Architectural Review Board Staff Report

Project type: Amended Architectural Elevations
Meeting Date: September 13, 2018
From: Cassie Harashe, Planner 
Location: 18491 Outlet Boulevard
Description: **Chesterfield Blue Valley, Lot 1H (Gander Outdoors):** 3rd Amended Architectural Elevations for a retail building on a 6.0 acre tract of land, zoned “PC” Planned Commercial District located on the northeast side of Outlet Boulevard between its intersection with Brasher Street and Blue Valley Avenue (17T130133).

Re: Amended Architectural Elevations for Gander Outdoors, 18491 Outlet Blvd.

Figure 3: Proposed East Elevations

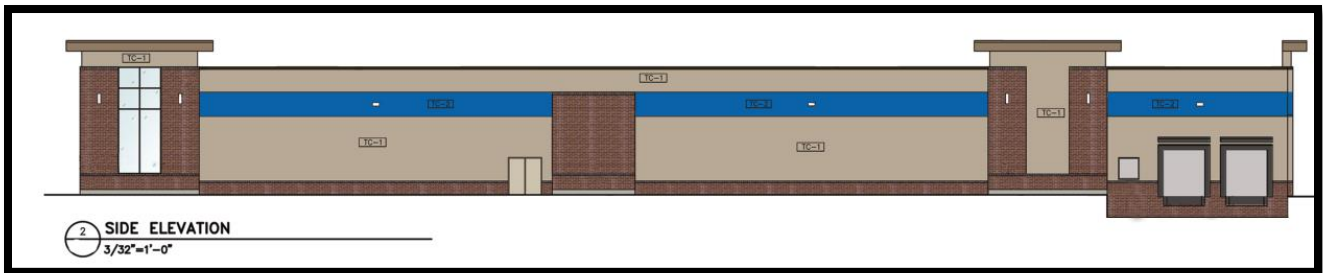
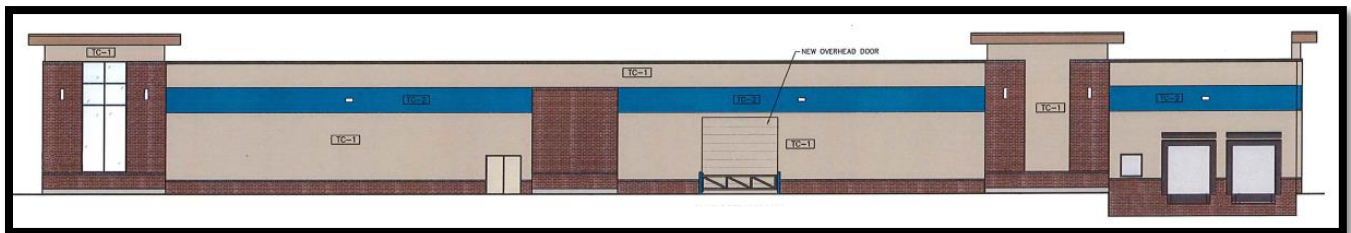
The applicant is proposing to add a new overhead door to the east elevation. The door will be painted to match the adjacent wall color, Sherwin Williams Universal Khaki. No other changes to the site are proposed at this time.

As mentioned at the outset of this report, the Chesterfield Blue Valley development is subject to a comprehensive design package that was approved by the Planning Commission in 2013. While the City’s Unified Development Code requires that the design of fencings, sound walls, carports, trash enclosures, rooftop screening, and similar site elements be integrated into the building design and constructed with similar materials, the Chesterfield Blue Valley design package provides even more specific language on how loading areas should be screened:

Screen Walls: Decorative screen walls are to be architectural in nature and provide a visual barrier for well-maintained utilities, service devices, compactor and loading areas.

The impacted elevation currently faces an undeveloped lot and is visible while traveling northwest along Outlet Boulevard and westerly along Chesterfield Airport Road, as shown in the following images.

Given the prominent location of the Gander Outdoors building and frontage along a major roadway, loading bays with overhead doors near the rear of the building are recessed and screened with a screening wall, as shown in Figure 6 below. This design intentionally seeks to limit views into unsightly areas reserved for loading and trash receptacles in accordance with the Chesterfield Blue Valley design package.

While some sites within the Chesterfield Blue Valley Development do not have overhead loading doors, those that do utilize screen wall design to limit visibility of these areas and maintain a retail rather than industrial character within the development. Again, this provides the “visual barrier” of loading areas as stipulated in the development’s design package. Burlington’s loading area is to the east of the building and the building is oriented to prevent views into the loading area from streets external to the Chesterfield Blue Valley development.

3 REAR ELEVATION (EAST)
3/32"=1'-0"

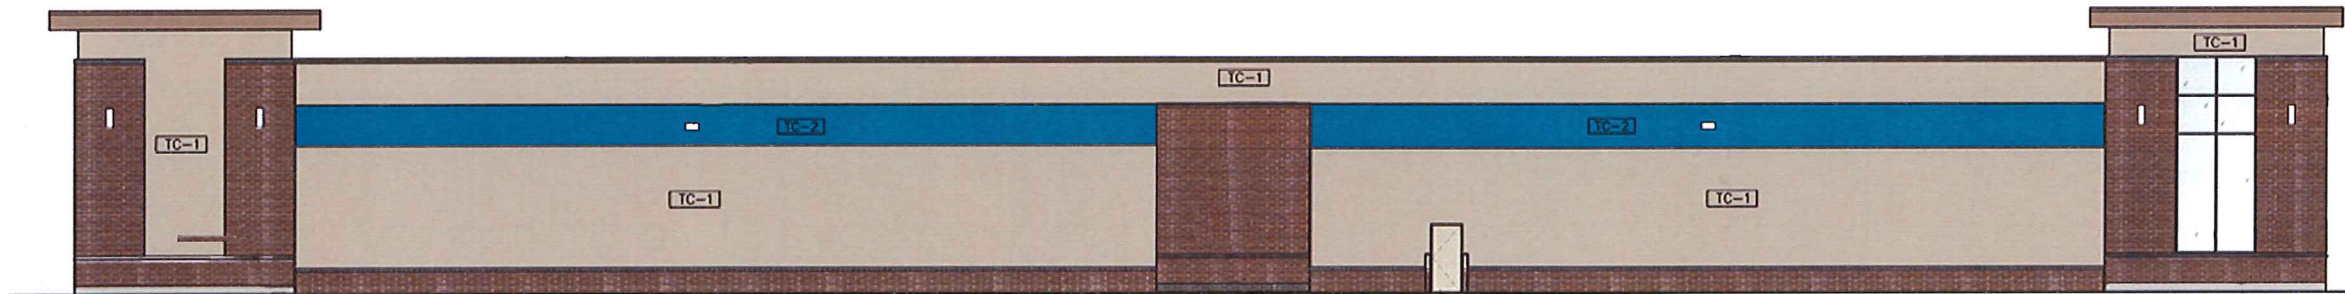
2. Section 31-04-01.D.4 states that screening materials for the exterior trash and storage area, service yards, loading docks and ramps, wood service poles, electric and gas meters, irrigation back flow prevention devices, and transformers should be substantial, durable, opaque, and well designed. The design of fencings, sound walls, carports, trash enclosures, rooftop screening, and similar site elements should be integrated into the building design and constructed with similar materials. Provide information on any screen proposed for the new overhead door.

- a. DBS Group, LLC proposes to paint the new overhead door, matching adjacent paint colors. See the attached Elevation Drawings for reference.
3. Signage review is a separate permitting process and is not within the purview of the Architectural Review Board. Accordingly, all signage be removed from the Architectural Elevations.
